Access Compliance Report

Public Rights-of-Way (Curb Ramps)

Intersection ID: 10029840	Main Street: KRISLYN_WOODS_PL	Cross Street: N/A	Location: SW
ADA ID: F71249E4F363	Ramp Type: Perp	Initial Pass/Fail: Fail	Overall Compliance: No
Severity Score: 21.25			
Codes/Mitigation Info/Possible Solution		Field Measurements/Component Compliance

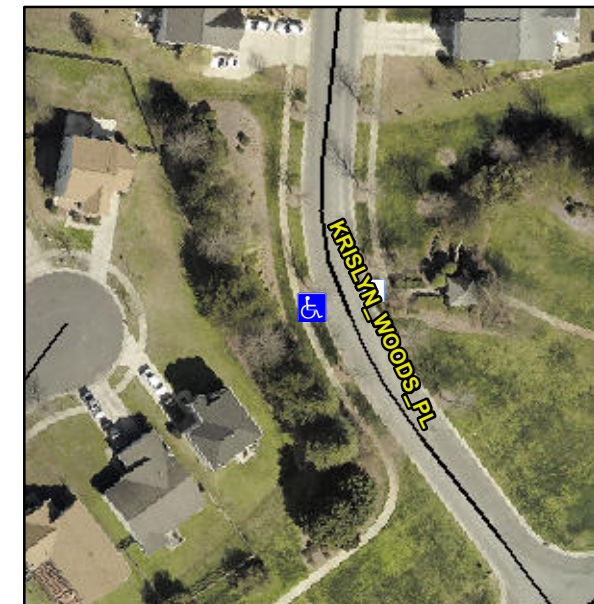
Not Found, R304.5.1, R304.2.2

Compliance	Description	Data	Compliance	Description	Data
N/A	Ramp Length (in)	85.0	No	Ramp Slope (%)	8.8
No	Ramp Width (in)	47.0	Yes	Ramp XSlope (%)	0.7
N/A	Flare Type LT	N/A	N/A	Flare Type RT	N/A
N/A	Flare Slope LT (%)	N/A	N/A	Flare Slope RT (%)	N/A
N/A	Flare Traversable LT?	N/A	N/A	Flare Traversable RT?	N/A
N/A	Landing Length (in)	N/A	N/A	DWS Provided?	N/A
N/A	Landing Width (in)	N/A	N/A	DWS Contrast?	N/A
N/A	Landing Slope (%)	N/A	N/A	DWS Length (in)	N/A
N/A	Landing X Slope (%)	N/A	N/A	DWS Full Width?	N/A
N/A	Landing Curb? (Y/N)	N/A	N/A	DWS Offset (in)	N/A
N/A	Shared Landing?	N/A			
N/A	Gutter Ponding?	N/A	N/A	Gutter Slope (%)	N/A
N/A	Gutter Lip Ht (in)	N/A	N/A	Gutter X Slope (%)	N/A
N/A	Painted X Walk1?	No	N/A	Painted X Walk2?	N/A
	X Walk 1 Direction	To E		X Walk 2 Direction	N/A
N/A	X Walk 1 Width (in)	N/A	N/A	X Walk 2 Width (in)	N/A
	X Walk 1 Slope (%)	3.3		X Walk 2 Slope (%)	N/A
	X Walk 1 X Slope (%)	1.3		X Walk 2 X Slope (%)	N/A

Remove & Replace Entire Ramp.
